Re Planning Commission Submittal – Follow Up Information Request from Planning Staff
Butler Street Apartments– Reese and Blake Fisher

Butler Street Apartments

21005.00 – North Butler Street Development – Follow Up Information

Image 1 – Grade Analysis/Determination of Lamp House and Proposed Development

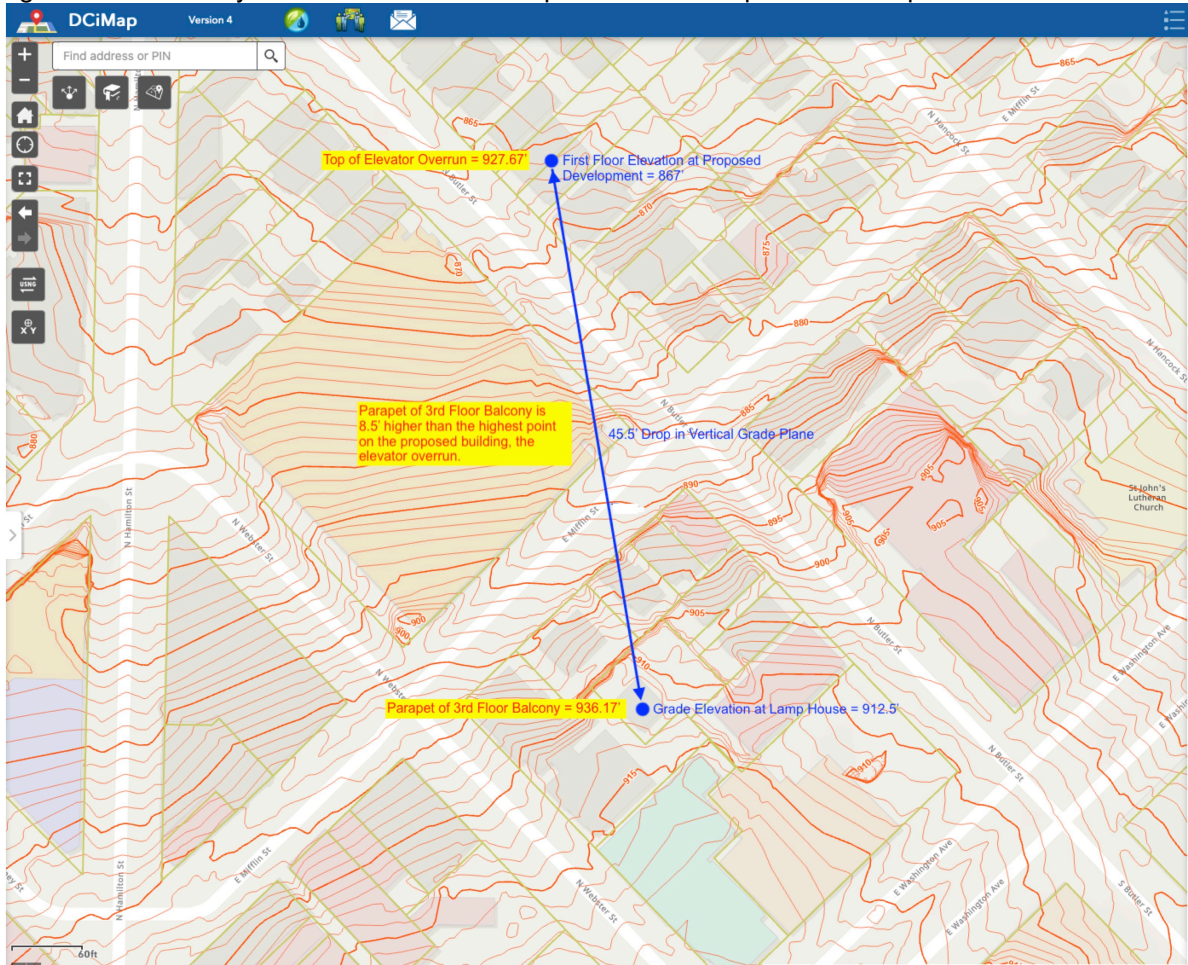
The second item Planning Staff requested was additional information on the study of the impact the proposed project has on views from the Lamp House. Below is an analysis of the proposal's impact based on the electronic 3D file provided by City Staff and that was used as part of the Report of the Lamp House Block Ad Hoc Plan Committee dated January 2014 and adopted as a supplement to the City's Downtown Plan March 2014. The development team has placed the proposed building within that model at the appropriate elevation related to the Lamp House based on data from DCiMap of Dane County that provides existing grading of the area. The diagram below shows that the first-floor elevation of the proposed building is 45.5' below the grade elevation at the Lamp House, and more importantly that the highest point of the proposed building (the elevator overrun) is 8.5' below the parapet of the 3rd floor balcony of the Lamp House. This data has then allowed the team to place the proposed building in the provided model to show that there is no impact to the view to Lake Mendota from the Lamp House. We have also included comparison images from those in the Ad Hoc Plan Committee report to illustrate this condition.

Image 4 – Aerial view of proposed building within same view as Image 3 above (No impact to view to Lake Mendota)

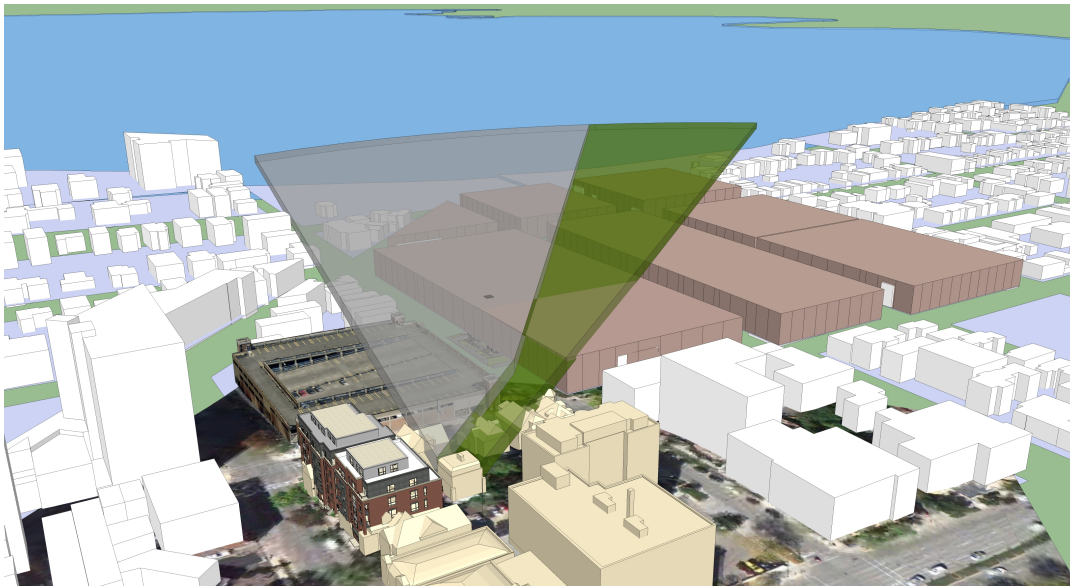
Image 3 – Aerial view excerpt from Page 17 of Ad Hoc Committee Report suggesting four stories has **little to no effect on these lake views**
